Access Compliance Report Public Rights-of-Way (Curb Ramps)

Main Street: NEARING_DR Cross Street: CHAPMAN_AVE Location: NE

ADA ID: RPRK210928174454 Ramp Type: Type 1 - Perpendicular Diagonal Initial Pass/Fail: Fail Overall Compliance: No Severity Score: 15

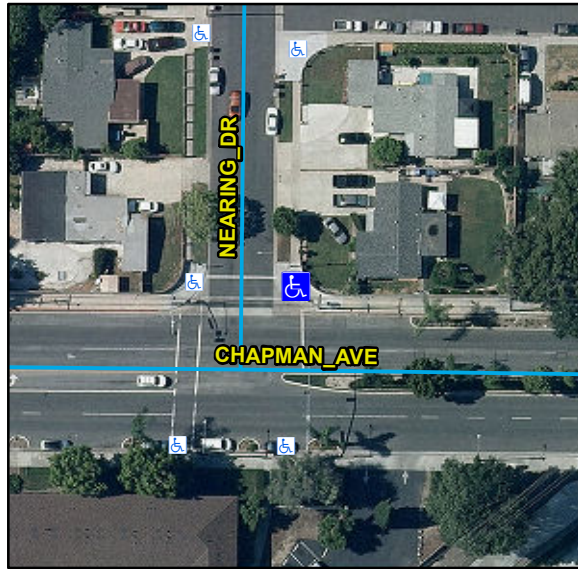
Compliance	Description	Data	Compliance	Description	Data
N/A	Ramp Length (in)	138	N/A	Flare Type LT	
Yes	Ramp Width (in)	48			N/A
No	Ramp Run Slope (%)	10.6	N/A	Flare Slope LT (%)	N/A
Yes	Ramp Cross Slope (%)	0.3	N/A	Flare Traversable LT	N/A
N/A	Landing Present	N/A	N/A	Flare Type RT	
N/A	Landing Length (in)	N/A			N/A
N/A	Landing Width (in)	N/A	N/A	Flare Slope RT (%)	N/A
N/A	Landing Run Slope (%)	N/A	N/A	Flare Traversable RT	N/A
N/A	Landing Cross Slope (%)	N/A	N/A	DWS Provided	N/A
N/A	Landing Movement Obstructed?	N/A	N/A	DWS Contrast	N/A
	Landing Movement Type	N/A	N/A	DWS Length (in)	N/A
N/A	Landing Shared	N/A	N/A	DWS Full Width	N/A
N/A	Clear Space	Yes	N/A	DWS Offset Left (in)	N/A
N/A	Clear Space To Crosswalk (in)	48	N/A	DWS Offset Right (in)	N/A
N/A	Marked Crosswalk 1	Yes	N/A	Marked Crosswalk 2	No
	Crossing 1 Direction	W		Crossing 2 Direction	S
	Marked Crosswalk 1 Width (in)	132		Marked Crosswalk 2 Width (in)	N/A

N/A	Ramp Inside Crosswalk 1	Yes	Yes	Ramp Inside Crosswalk 2	N/A
	Crossing 1 Slope (%)	8.5		Crossing 2 Slope (%)	1.1
	Crossing 1 Cross Slope (%)	4.5		Crossing 2 Cross Slope (%)	0.6
N/A	Gutter Ponding	N/A	No	Curb Slope	10.9
Yes	Gutter Lip Height (in)	0		Road Run Slope (%)	2.3
N/A	Gutter Run Slope (%)	N/A		Road Cross Slope (%)	5.9
N/A	Gutter Cross Slope (%)	N/A			
Yes	Overall Surface Condition: Acceptable		Yes	Perp Joint Present	Yes
	Cross Gutter Present?	Yes		Spandrel Present?	Yes
	Replace Cross Gutter?	No		Replace Spandrel?	No

Remove & Replace Curb Ramp With Two New Directional Ramps or Equivalent.

R304.2.2, STD 1115
